This gallery shows some pictures of bad solderings - they should prevent you from making the same errors (feel free to add even more pictures here!)

From: <https://www.midibox.org/dokuwiki/> - MIDibox

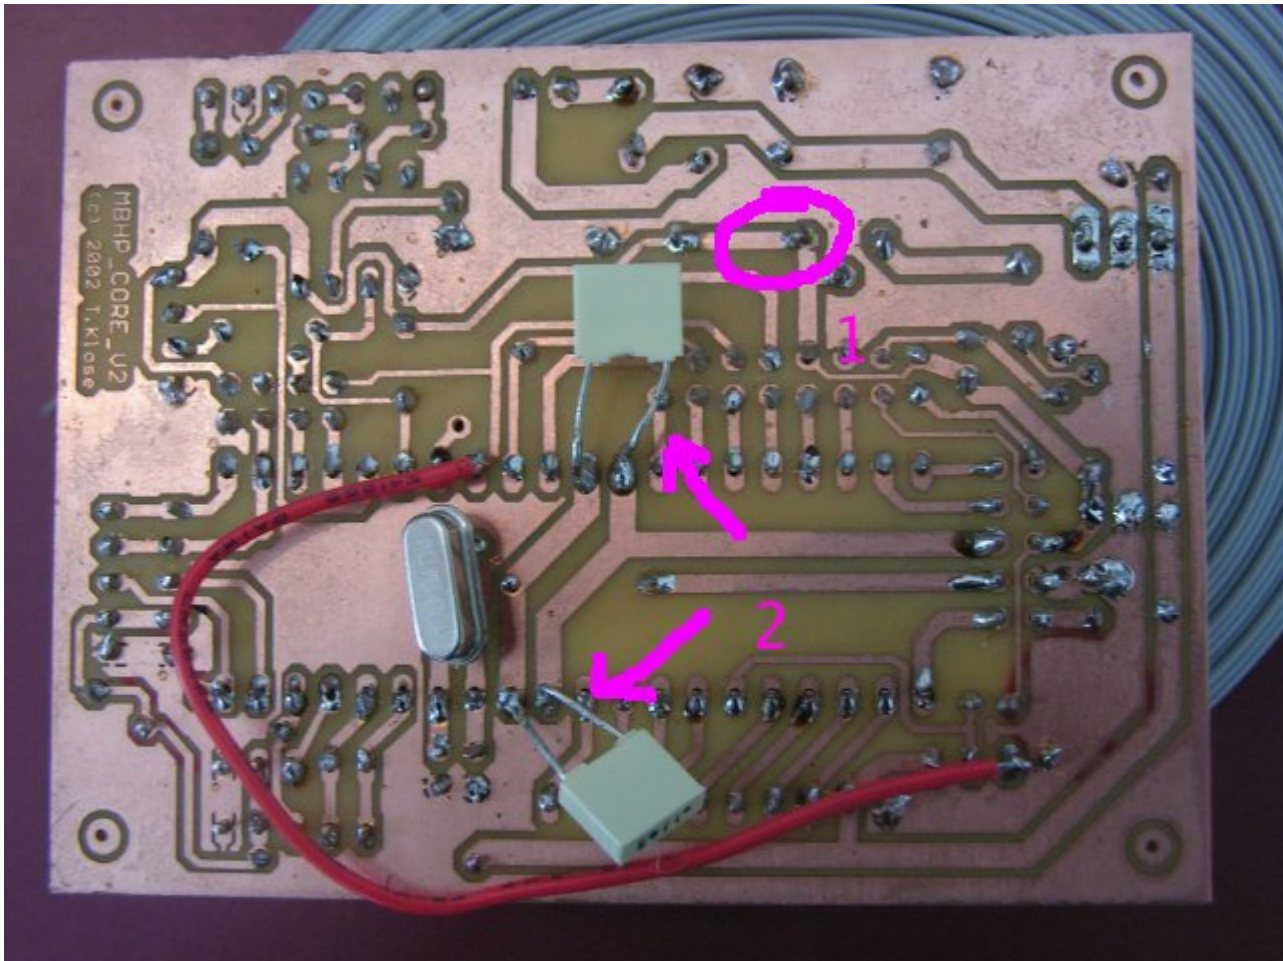
1: The core module has some badly soldered connections (loose), which could lead to failures. There are also missing solderings (e.g. 33pF cap below crystal). It makes sense to solder each pad again, the [Soldering](#) guide in the Wiki gives some useful tips

2: The legs of the caps should be cut, otherwise they can cause a short circuit which can damage the PIC!

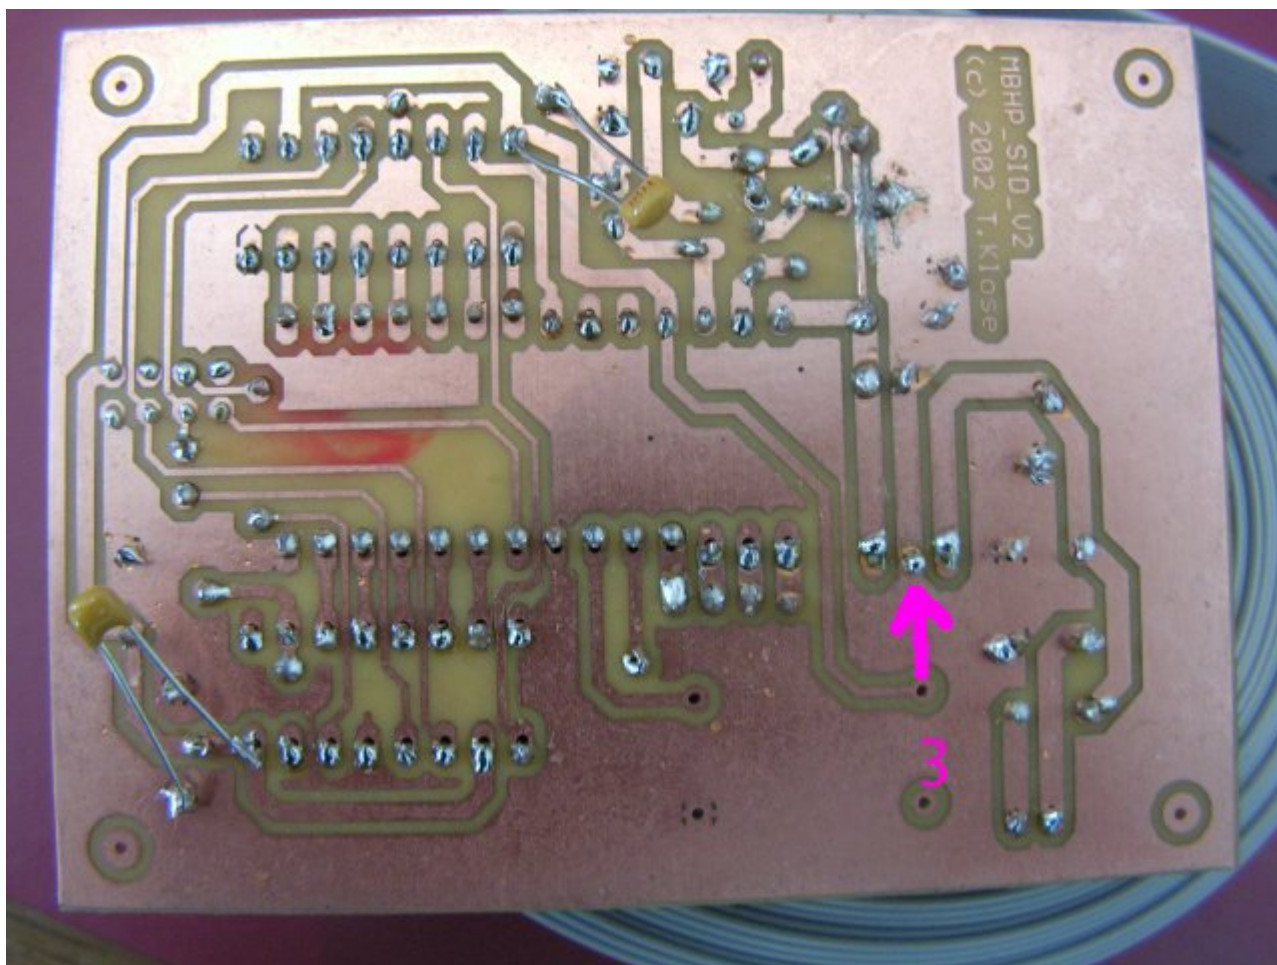
3: This seems to be a bad ground connection directly at the 78xx - it can lead to the wrong voltage. Here the same: just solder the pads again, it will help
And same as above: the long cap legs need to be cut, the danger of shorting out is too high!
